# Maldon District Council (MDC)

## Written Submissions on Oral Representations made at Issue Specific Hearings

### Issue Specific Hearing 1 Environmental Matters – 28 February 2023

Figure 3: Access track to Cadent Gas Main Diversion

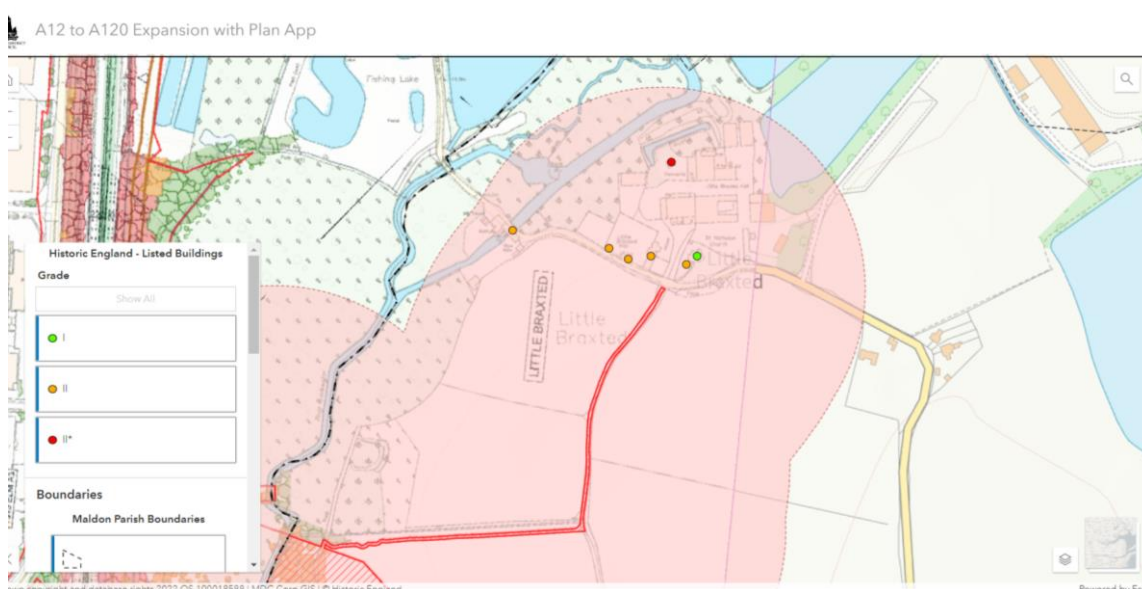
3.1 The proposed Cadent gas main diversion includes provision of a maintenance access track from Little Braxted Lane. Little Braxted Lane connects to the A12 at Junction 22, but it is also highly constrained, is a single-track lane, with 2m width restrictions and passing places, which passes over a number of bridges, one of which has a 3-Tonne weight limit and one of which is a listed structure (Little Braxted Mill House Bridge) in its own right. There are a number of other heritage assets Little Braxted Lane covering all Grades, and the entrance to the proposed access track would be opposite the Grade I Listed Church of St Nicholas (Listing Entry 1111066), the Grade II Listed Church of St Nicholas Monument (Listing 1146792) and the Grade II Listed Little Braxted Hall and railings enclosing garden (Listing 1111063) as set out on MDC's mapping extract below, which also illustrates the presence of land in the Order Limits within the red line.

3.2 MDC is concerned to know if the applicant has fully considered the likely impact of the use of Little Braxted Lane for maintenance vehicles on the heritage assets along it. The

Council is concerned after a recent incident involving the Applicant's contractors which is set out in more detail in MDC's LIR, which affected residents and businesses which use the lane for access.
